# Determination 2005/169

## Single means of escape from a high-rise apartment building at 10-14 Upper Queen Street, Auckland City

Fig. 1. Typical floor plan, East tower. LO4-L11 reproduced from TP\_04 rev B

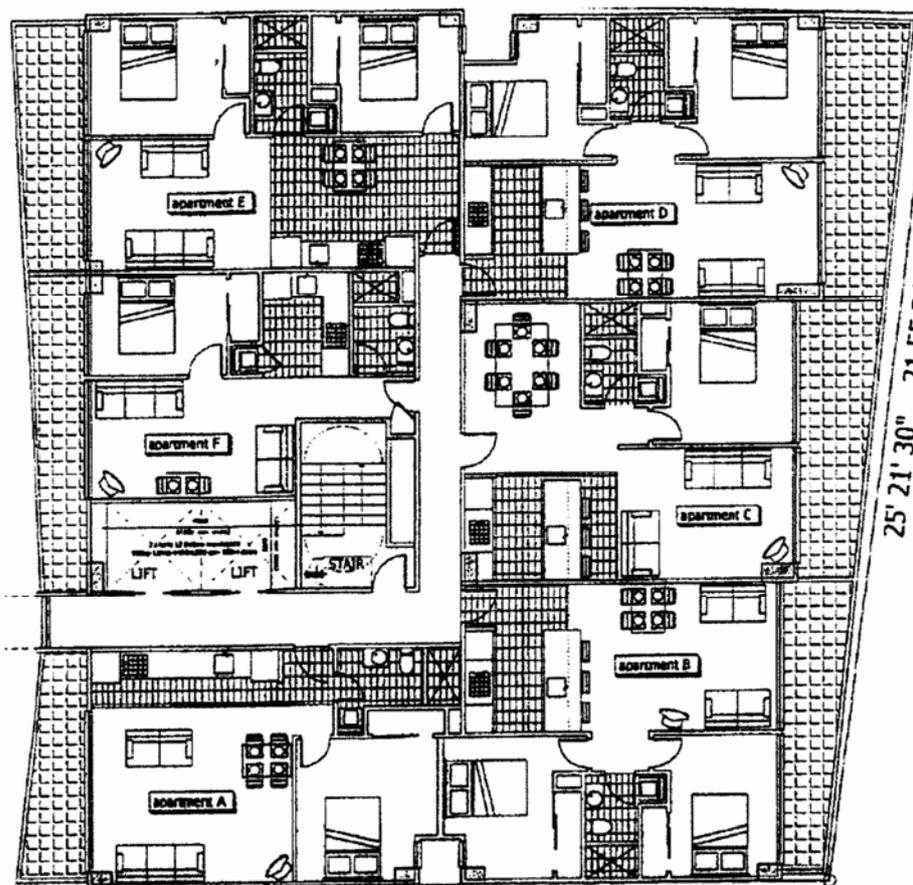
The experts also noted concerns that at ground level the escape route became an open path and they believed that this did not comply with the Building Code. However, the experts noted that this issue was not part of the determination. This is discussed in more detail in 6.3.7.

To my mind, it is questionable whether this important fire separation has been adequately designed and detailed. There is a limited amount of description in the fire report but nothing on the architectural drawings. The fire report predates the plans, and when asked, the fire engineer declined to confirm that the plans reflected his design. That is of concern and needs to be reviewed by the territorial authority.

- 7.3.14 These issues, whilst very important, are matters of detail rather than design philosophy or methodology. The escape route from the stair landing to the final exit is required to be a safe path, particularly so in this building where there is only a single escape route. These are issues that the territorial authority should satisfy themselves on before issuing a consent.

- (c) The territorial authority should also verify the adequacy of the exitway from the stairs ground floor landing to the final exit.
- (d) I require the territorial authority to provide me with a report within two months of issuing the compliance schedule confirming that these conditions have been met.

Fig. 3. Compliant building – Building C<sup>3</sup>. (Note additional stairwell lower left)

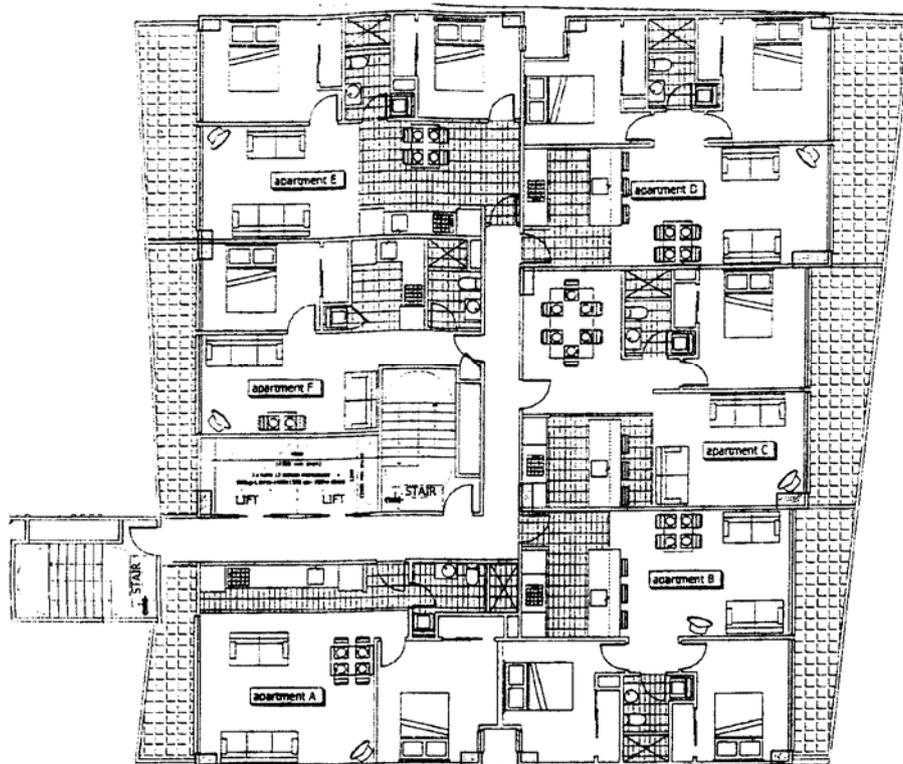
- 5.3.2 For the purposes of analysis, the experts analysed two buildings. One of these being the subject building, referred to hereinafter as Building A. This building is then compared with an “idealised” building, referred to as Building C, in the risk assessment. Building C is of the same height, plan area, and occupant load as Building A, but as it has two stairways, it complies with C/AS1.

- 5.7.1.1 The design philosophy that is being proposed and tested in the risk analysis is that as Building A lacks a second stair in comparison to Building C, it needs to have sufficient compensation to overcome this difference in design features. In this case the compensation is the enhanced sprinkler system and the stairwell pressurisation system, along with fire hose reels, extinguishers, a fire hydrant system and emergency lighting.

Fig. 4. Risk comparison of Building C and Building A.

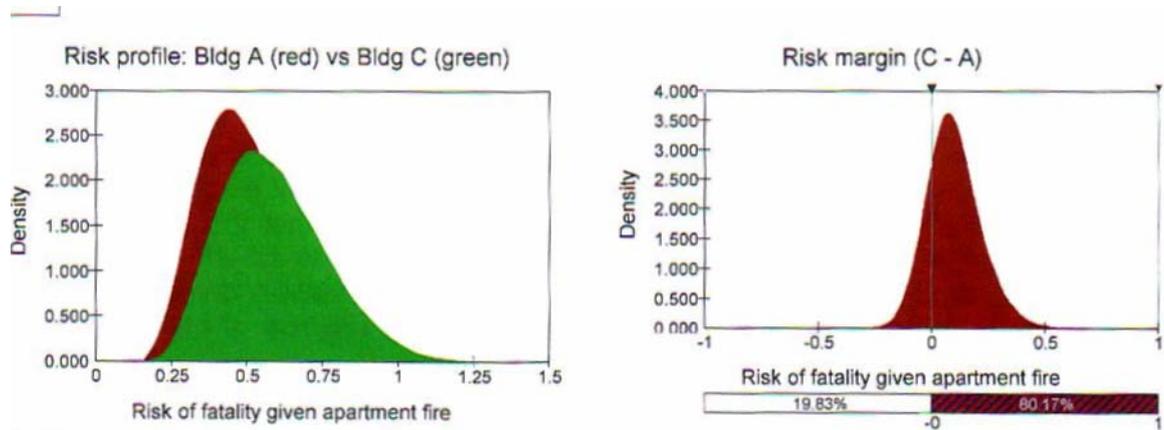
- 6.6.1.2 The purpose of the various analyses is to look at the "sensitivity" of the margin to various design features.
- 6.6.1.3 The results from the experts' analysis of the subject Building A in comparison to the C/AS1 compliant building (Building C) are given graphically in Figure 4 (below). This is the base case (time dependent).
- 6.6.1.4 The graphs are generated from the outputs from the @RISK computer programme. The risk profiles of the two buildings from the @RISK computer analysis are overlaid on each other to show the risk profiles of the buildings in relation to each other. This shows the risk profile for the proposed building (Building A) sitting to the left of the corresponding profile of the control building (Building C), and indicates that Building A has a lower risk in the event of fire. The second graph

shows the risk margin, and is the net risk profile of Building C minus the net risk profile of Building A. The result shows that there is a risk margin of 80% in the base case.

6.6.1.5 The experts noted that the results include safety margins and that two comparable or equivalent buildings will have a margin of 50%. The possibility that things will go randomly wrong in Building A compared with things going right in Building C is covered by the variability in the input parameters. A margin of greater than 50% is sought.

- 6.6.1.6 The experts point out that in Determination 2005/109, 74% for the base case was not considered high enough. By comparison, the corresponding margin for Building A in the current analysis is 80% (for the base case), which is above the upper limit of Determination 2005/109.

- 6.6.1.7 Permutation 1 from the table above is the base case with a Class B water supply rather than a Class A supply as recommended in the Determination. The margin decreases from 80% to 73%.

- 7.2.6 As discussed in paragraph 5.9.1.1, the design as proposed by the applicant (not the base case) has a margin of 73%. Clearly this is not acceptable as it falls short of the 75% threshold. However the expert has analysed the base case of a compliant building with a Class A water supply in lieu of Class B. This provides a margin of 80% which is acceptable.
